900-00001-01 Rework kit Fast and The Furious Drift

SERVICE BULLETIN

Models Affected: "The Fast and the Furious DRIFT" S/N 1000 – 3477, and "The Fast and The Furious" S/N 7576-8275

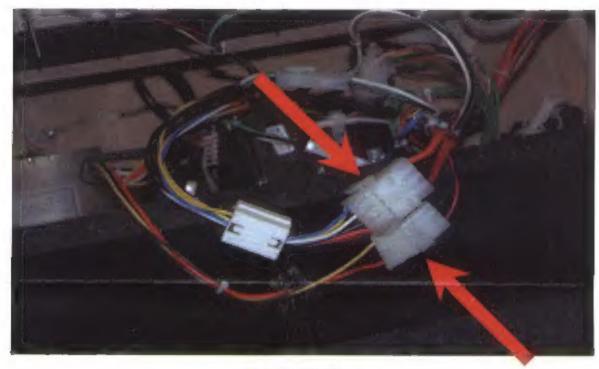
Cause: Improper standoffs were installed on a range of our PCB's. Overtightening during game assembly compressed these standoffs, leading to increased stress on the board and, in rare cases due to shock from transport or placement, fracture. The board fracture then introduces shorts and lowimpedance circuits between 5V and GND.

Remedy: Relieve over-tightening and replace standoffs if necessary; add fuse-holder (for general improved protection against over-current situations).

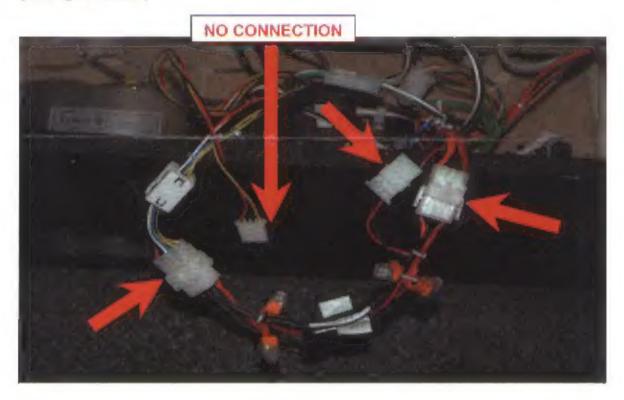
- 5. Disconnect both connectors.
- Connect the fuseholder assembly in between the power supply and system harness via the 12-pin connectors. Then, connect ONLY THE SYSTEM SIDE of the 4-pin connector, leaving the power-supply side free (see figure below)

- Connect the 4-pin connector on the fuseholder assembly to the system harness.
- 8. Locate the I/O board (for Drift / for FnF)
- Visually inspect the corners of the board for fractures or bowing. If the board is fractured, remove and contact Betson for an immediate replacement at 1-800-753-2513.
- 10. Loosen the screws to relieve pressure on the board.
- 11. Replace the standoffs with the standoffs enclosed in the kit, if necessary
- 12. Replace the back door and securely fasten.
- 13. Reconnect power.
